Compliance to LIGO Modifications on GS-13

David McClung

Feb. 23, 2009

Table 1. Part Numbers Reference Table for Custom LIGO GS-13s.

Figure 1. Setscrews Used on GS-13.

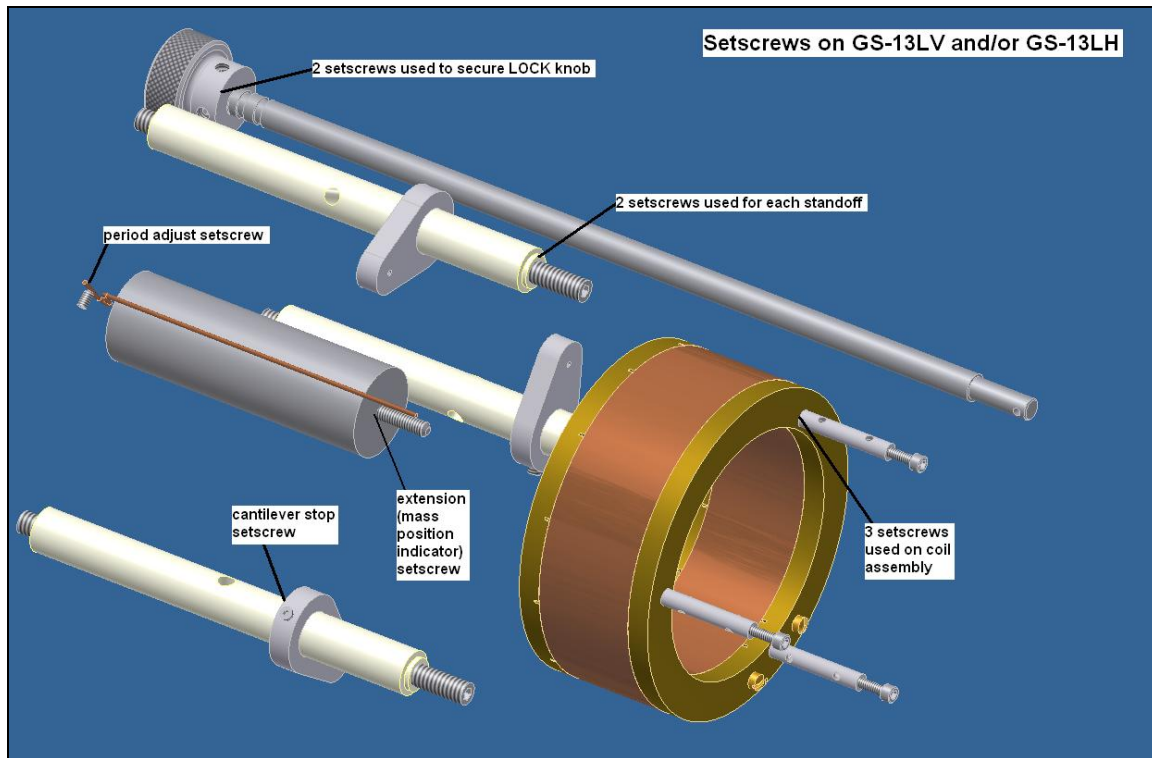
- 1) *Setscrews secured with thread-locker.* Figure 1 shows all setscrews used in GS-13 (horizontal units don't have all of those present). All assembly drawings will be reviewed to ensure compliance.
- 2) *Electrical connector orientation.* Final assembly drawings for GS-13LV, and GS-13LH will include view and note of connector orientation to ensure compliance. Figure 2 shows a front view of the GS-13 for reference. Figure 3 shows a front view of the GS-13LV. Figure 4 shows a front view of the GS-13LH.
- 3) *Hole Sealing:* We opt to have customized parts without handle, front horizontal foot, bubble level (GS-13LH only per Figure 4– if agreed), and rear horizontal foot holes. Figure 3, Figure 4, and Figure 6 shows our intent. Figure 5 shows a rear view of the GS-13 for reference.

Figure 3. Front View of GS-13LV.

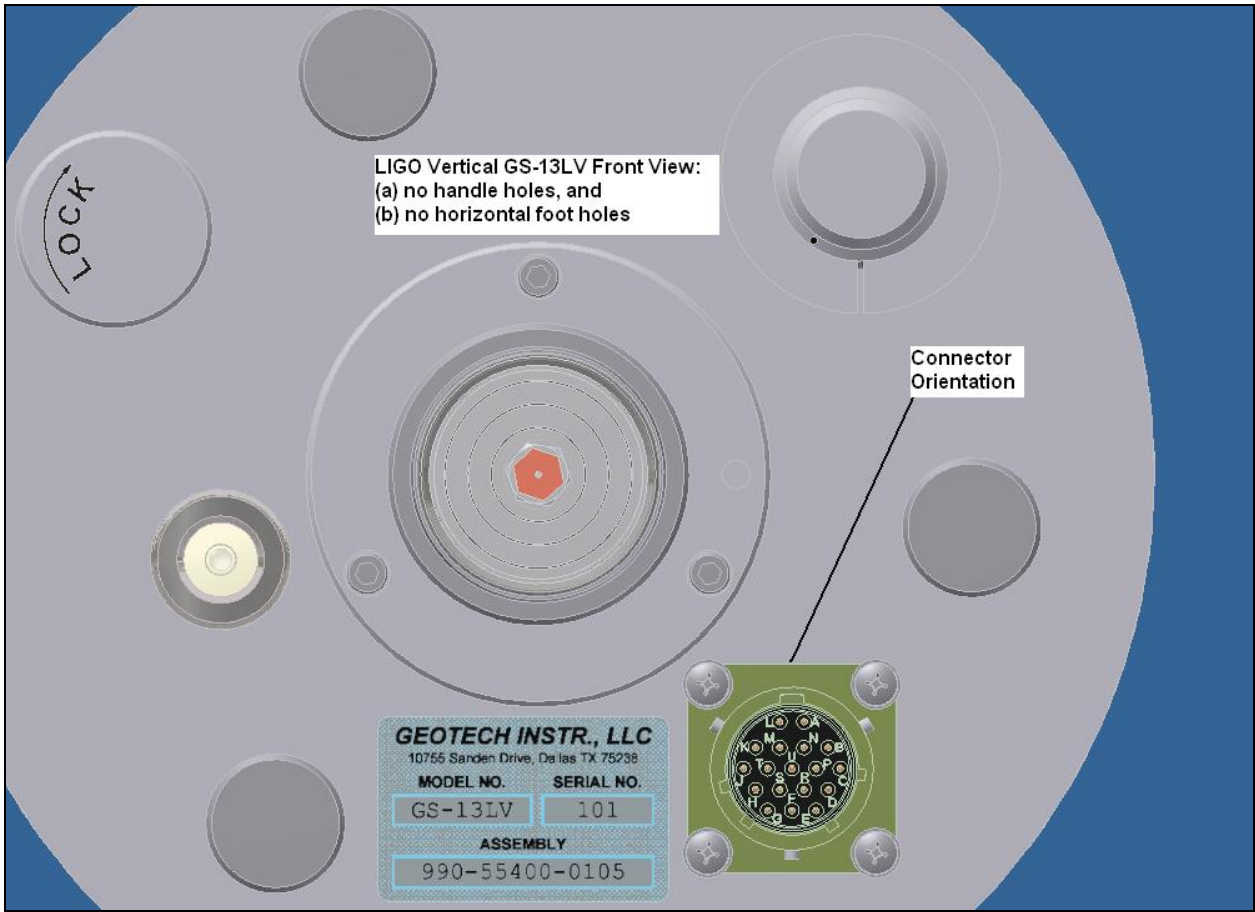
- (b) *Remove calibration magnet.* Refer to Figure 8 for compliance.
(c) *Remove the handle.* Refer to Figure 3 for compliance.
(d) *Remove the front horizontal foot.* Refer to Figure 3 for compliance.
(e) *Remove the rear horizontal foot.* Refer to Figure 6 for compliance.
(f) *Remove adjustable feet.* Refer to Figure 6 for compliance.

(h) *Seal holes.* Refer to Figure 3 and Figure 6 for compliance.

- (A) We would like to remove the bubble level from the horizontal LIGO GS-13 per Figure 4,
- (B) We would like to return to the welded case assembly per Figure 6 (not the dip-brazed as in the previous batch). This case was also less problematic for LIGO.
- (C) Please confirm our assumptions made in the "Visual Inspection" section, parts (b), (c) and (e).

- (a) *Remove calibration coil and cap.* Figure 11 shows a section view of GS-13LH for compliance.
- (b) *Remove calibration magnet.* Refer to Figure 11.
- (c) *Remove the handle.* Refer to Figure 4.
- (d) *Remove the front horizontal foot.* Refer to Figure 4.
- (e) *Remove the rear horizontal foot assembly.* Refer to Figure 6.
- (f) *Remove the adjustable feet.* Refer to Figure 6.

- (i) *Seal holes.* Refer to Figure 4 and Figure 6.
- (j) *Calibration Magnet Assembly Displacement Mass.* Refer to Figure 10 for view of design.

Figure 6. Rear Views of GS-13LV and GS-13LH are the Same.

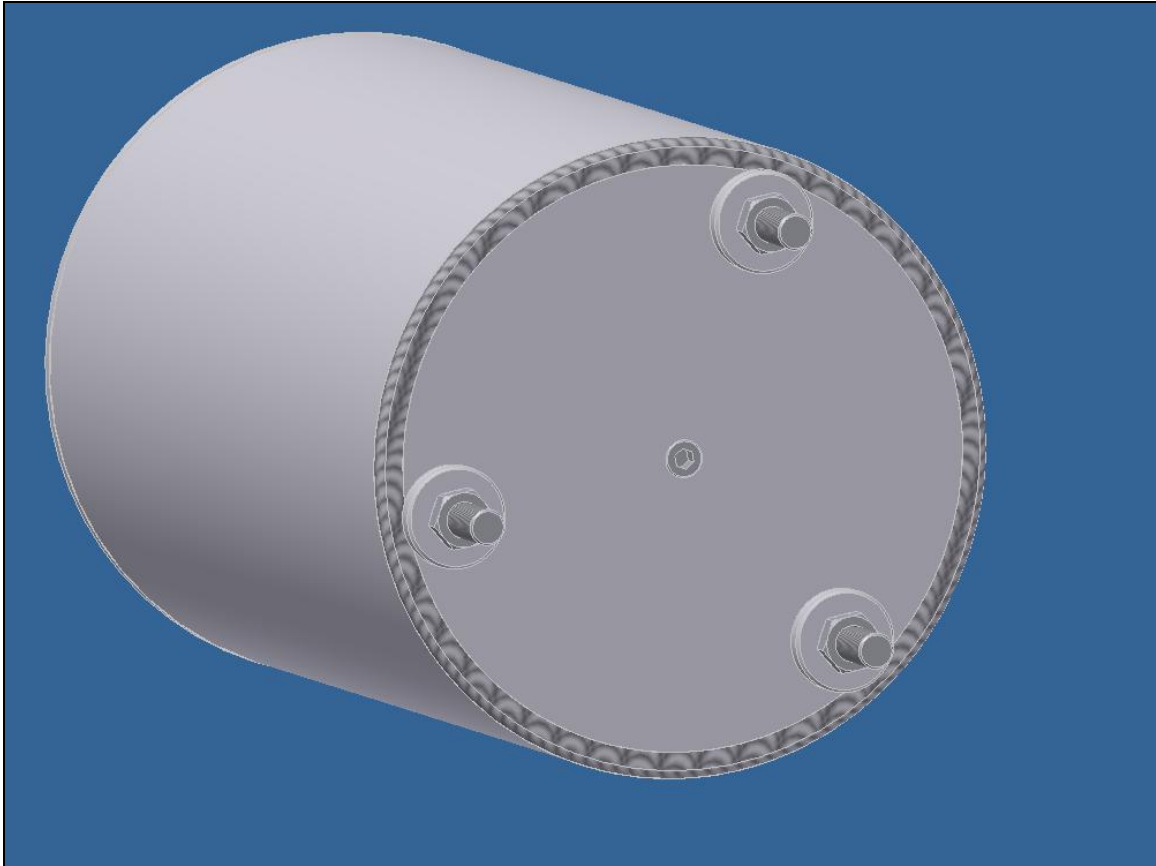
4) *No Paint.* GS-13LV, and GS-13LH will not have painted cases per Figure 6.

Figure 8. GS-13LV Section View of Previous Calibration Coil and Magnet Area.

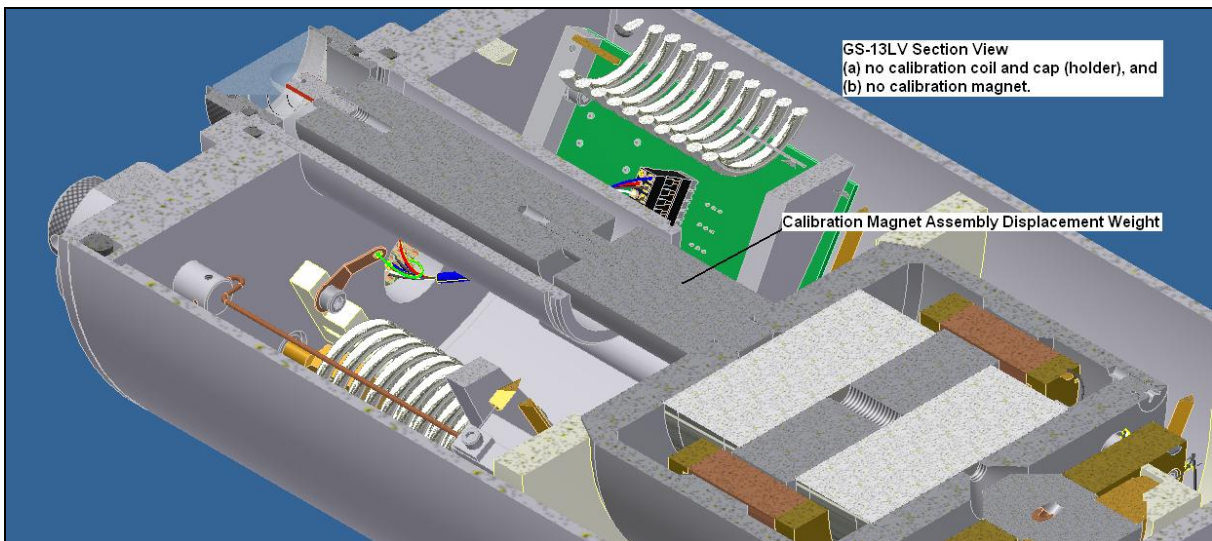
- (a) *Remove calibration coil and cap.* Figure 7 shows a section view of the GS-13 for reference. Figure 8 shows a section view of the GS-13LV calibration magnet assembly area. For both the GS-13LV and GS-13LH (Figure 11), the calibration coil and cap are removed.

Figure 9. Vibration Damping O-Ring.

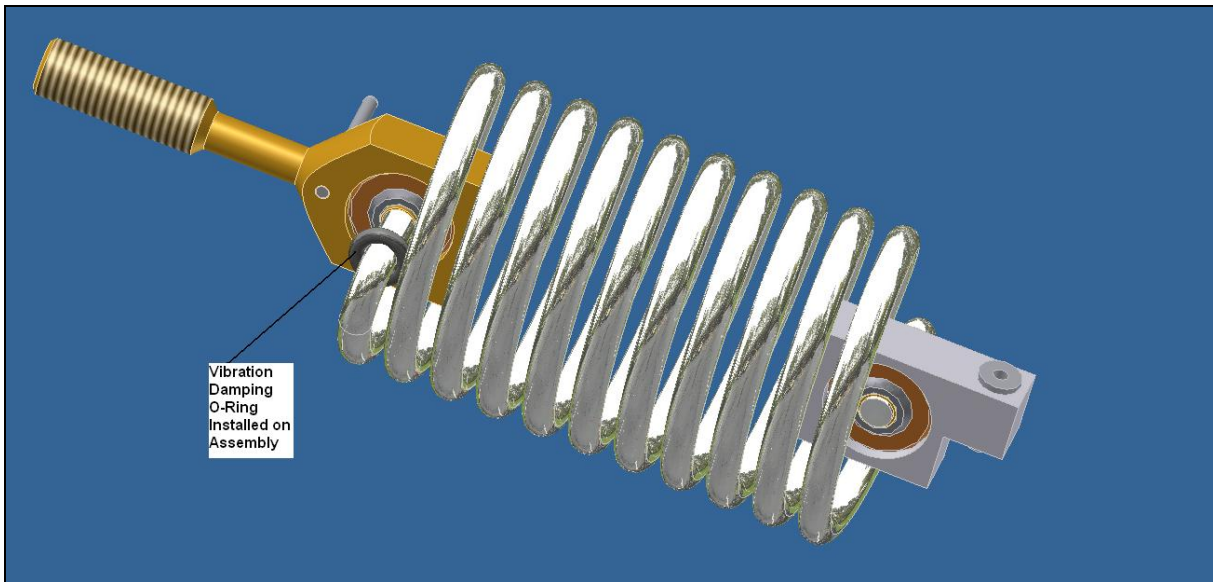
(g) *Install o-ring on spring assembly.* Refer to Figure 9 for compliance.

Figure 10. GS-13 Magnet Assembly and GS-13LV / LH Displacement Mass.

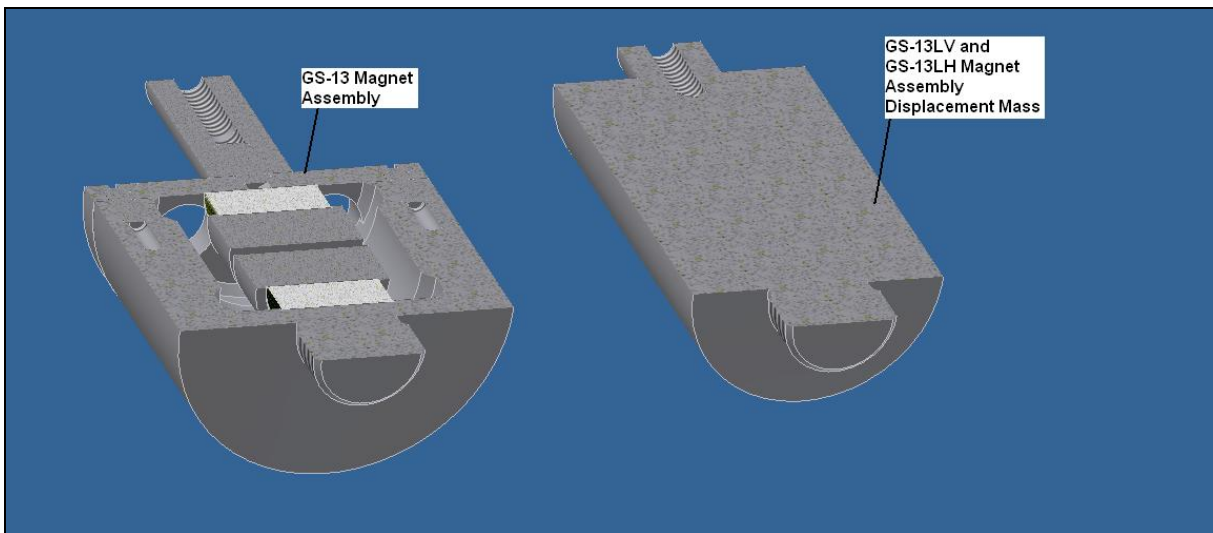
(i) *Calibration Magnet Assembly Displacement Mass.* Refer to Figure 10 for view of design.

Figure 11. GS-13LH Section View of Previous Calibration Coil Area.

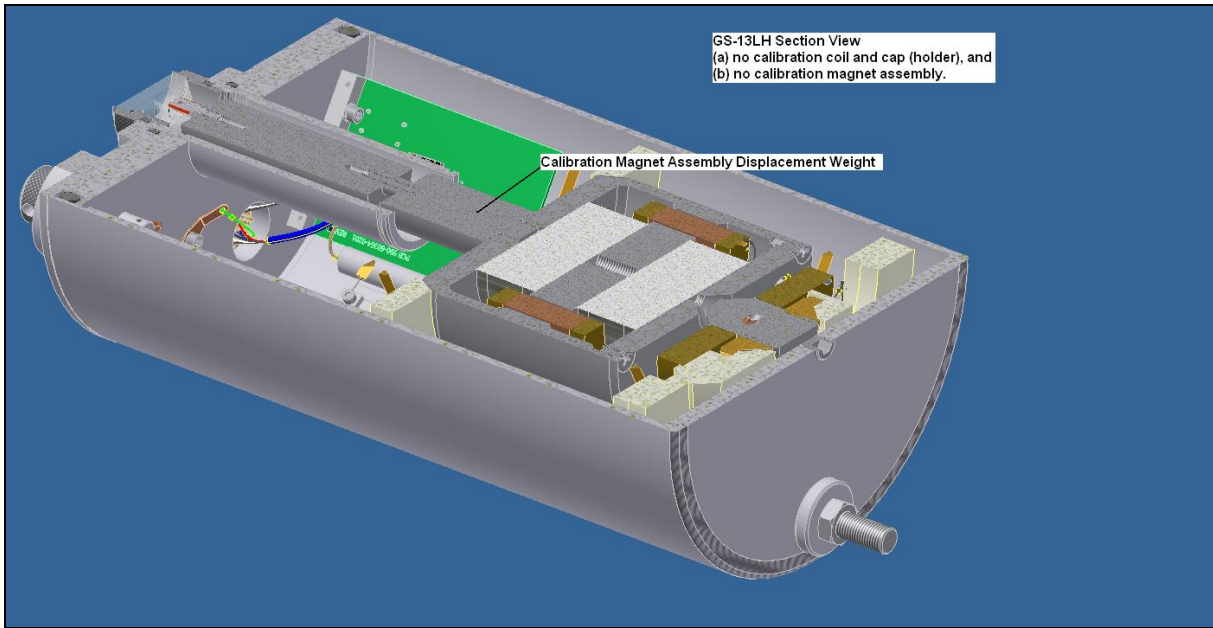
- (g) Remove the 3 vertical offload springs. Refer to Figure 11 for section view. Figure 12 shows details of the top end of spring (now removed), and Figure 13 shows the bottom end of spring (now removed).

Figure 12. Inside Front View of GS-13LH Showing Top End of Spring Assembly (now Removed).

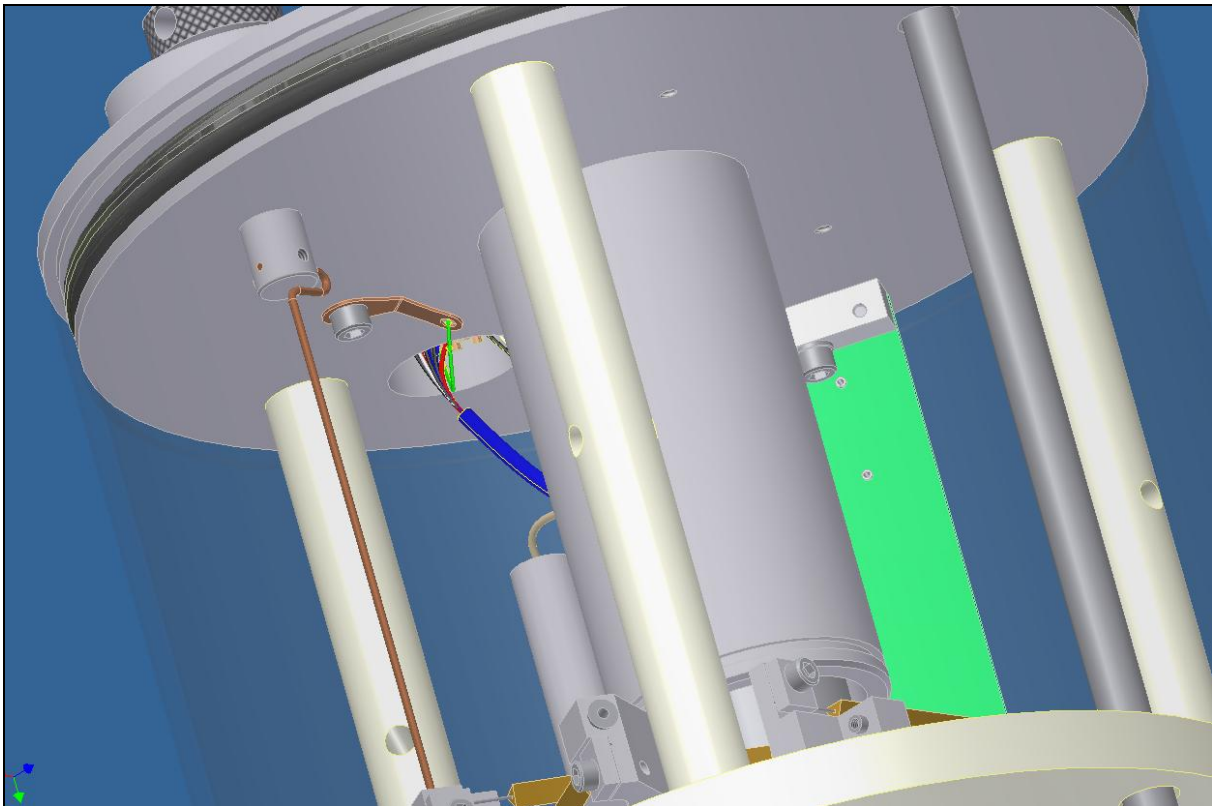
- (h) *Remove mechanisms associated with vertical offload springs.* Refer to Figure 14 for pictorial view of difference between GS-13LV and GS-13LH.
- *spring tension adjust knobs, screws, bushings, etc..* All items are removed. Refer to Figure 4, and Figure 12.
 - *cantilever assemblies which connect spring to mass.* Refer to Figure 13.
 - *flexures for the spring and cantilevers.* Refer to Figure 13.
 - *cantilever stops.* Refer to Figure 13.
 - *spring guides.* Refer to Figure 12.
 - *list for approval.* See Table 2 for a list of parts shown in Figure 14.

Figure 15. Visual Inspection Parts.

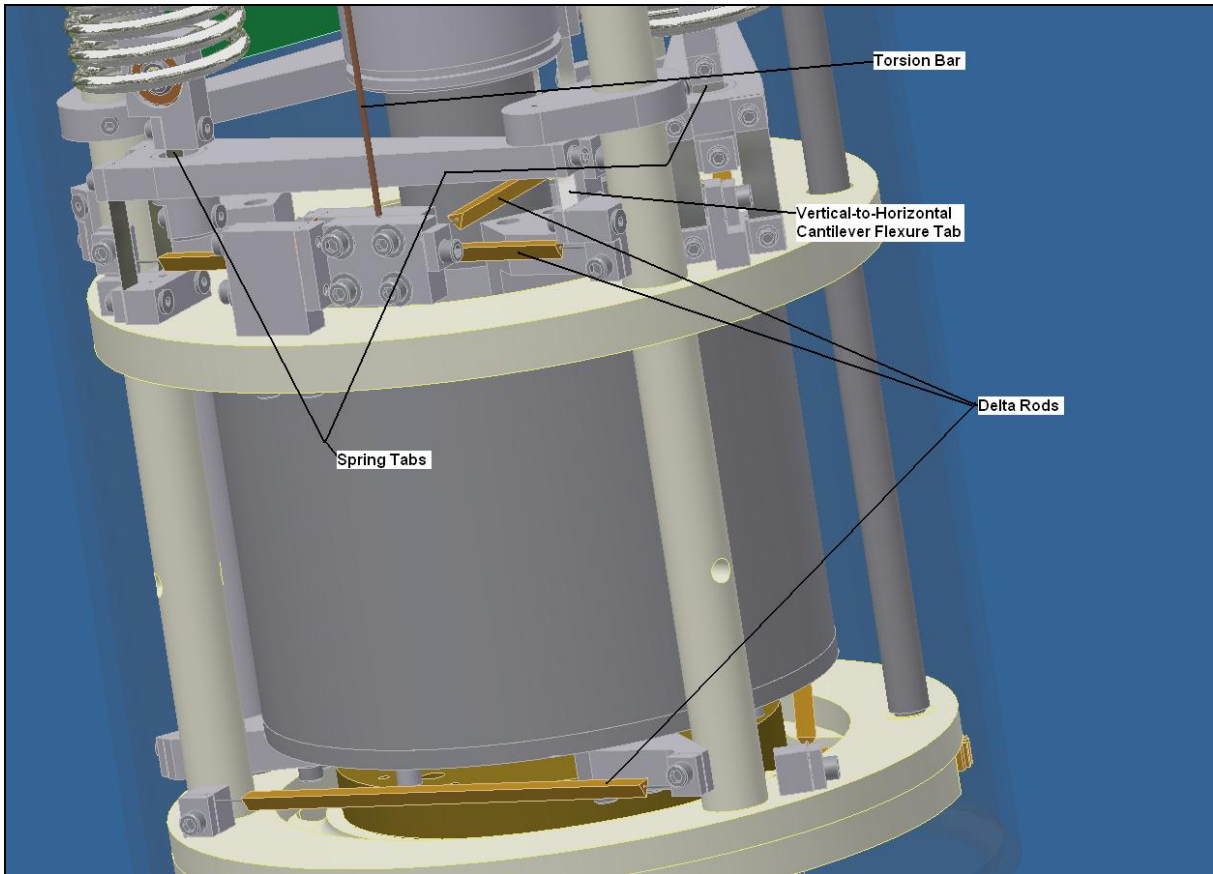
- (a) *Inspect the delta rod.* Seven delta rods will be inspected as shown in Figure 15.
- (b) *Inspect tension rod.* **It is assumed** this is the same as the torsion bar shown in Figure 15.
- (c) *Inspect spring tabs.* **It is assumed** that the locations of these particular tabs, as shown in Figure 15, are correct.
- (d) *Inspect wiring interference.* Notes will be added to assembly drawings as required and assemblers briefed on this.
- (e) *Inspect vertical-to-horizontal cantilever flexure tab.* **It is assumed** that this requirement is no longer applicable, since vertical units will not be converted into horizontal ones. Refer to Figure 15 for location of this tab.
- (f) *Check proper unlocking.* Assembly and test documentation will be reviewed to ensure compliance. Notes will be added to assembly drawing to ensure oil-free (non-sticky) contact surfaces during assembly.
